CITY OF LINCOLN NEBRASKA

INDIVIDUAL SEWAGE SYSTEM CONSTRUCTION — October 27, 1971

FORM HD-32(67) APPLICATION FOR PERMIT TO CONSTRUCT INDIVIDUAL SEWAGE DISPOSAL SYSTEM
City Ordinance No. 9150

FILE NO. 191

TYPICAL SKETCHES

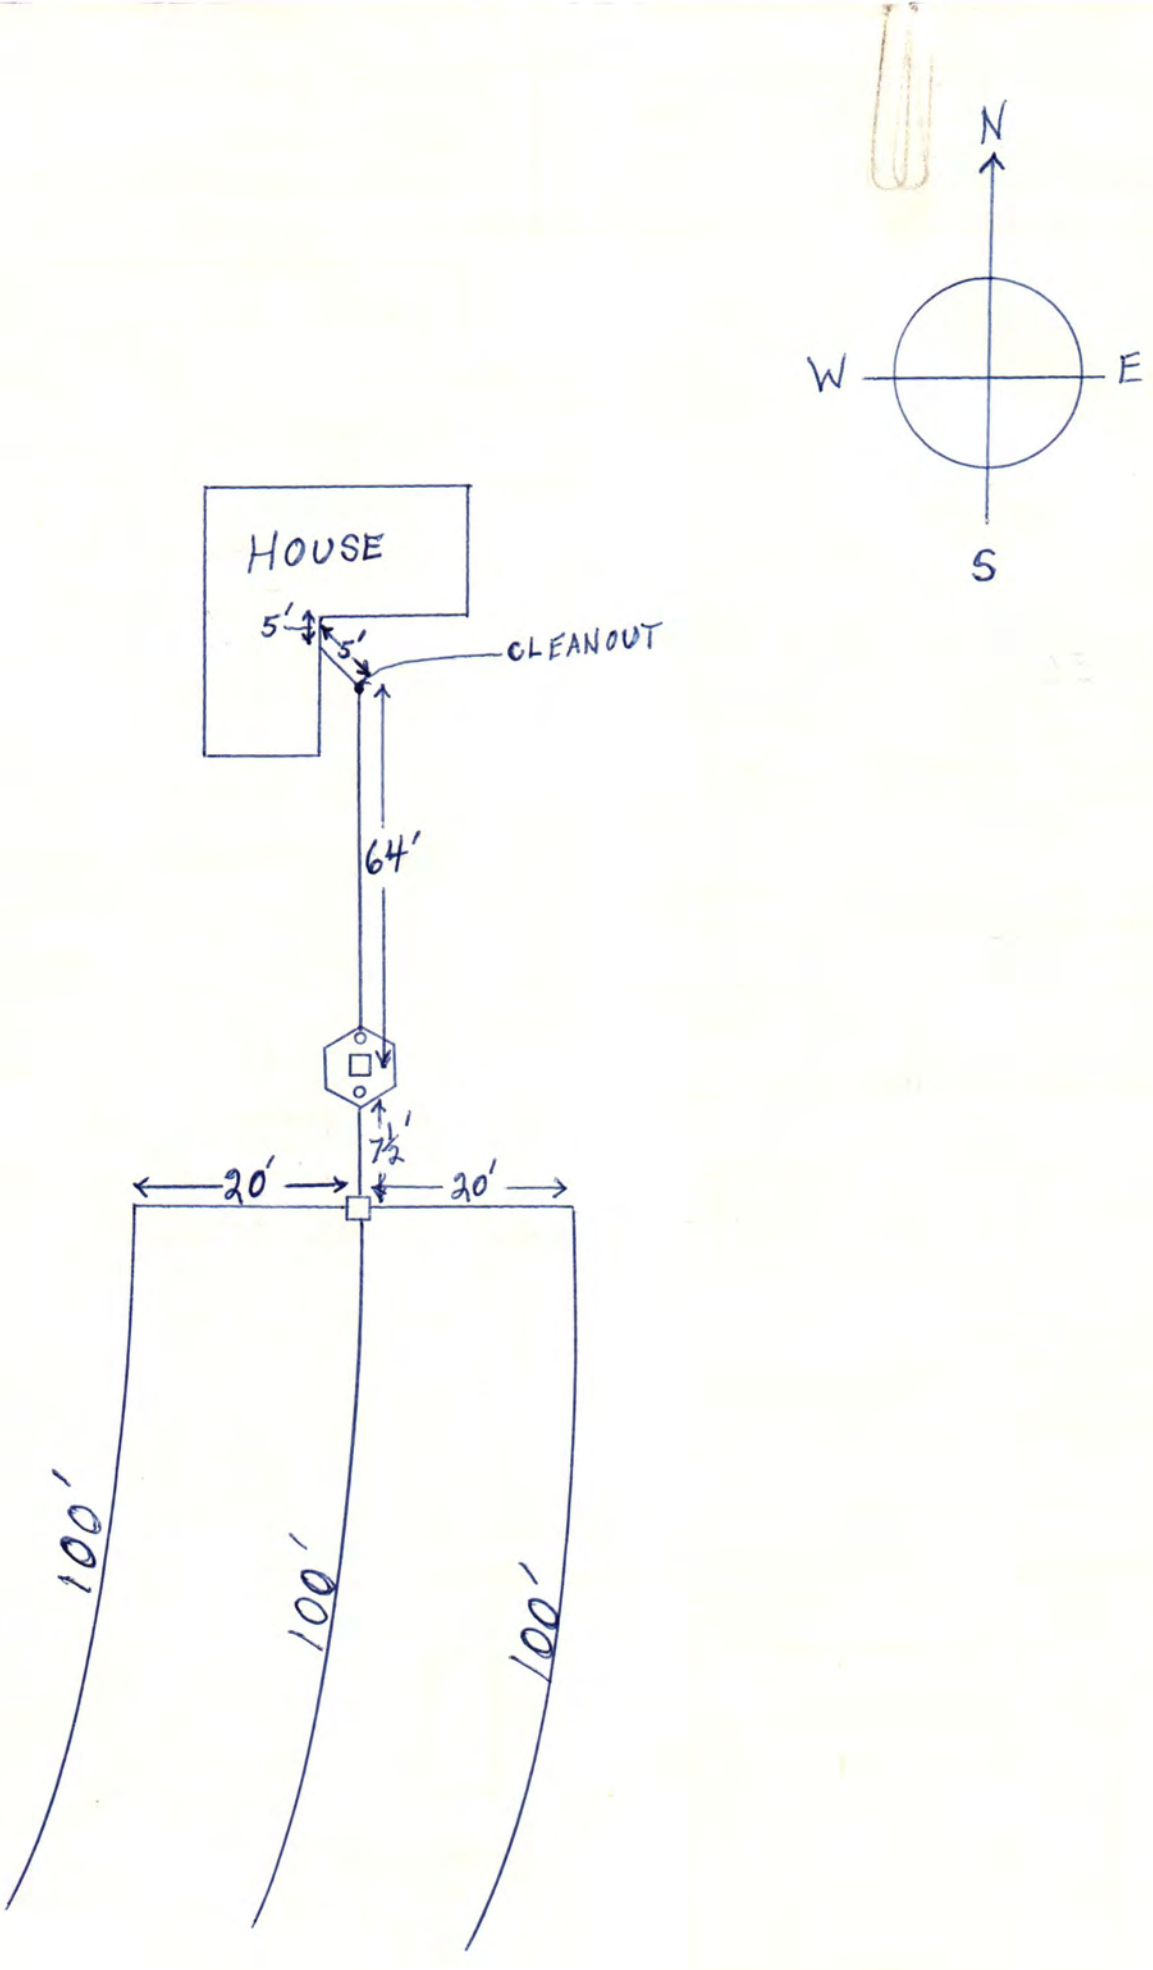
REMARKS: Too slow for regular system. System will have to be modified.
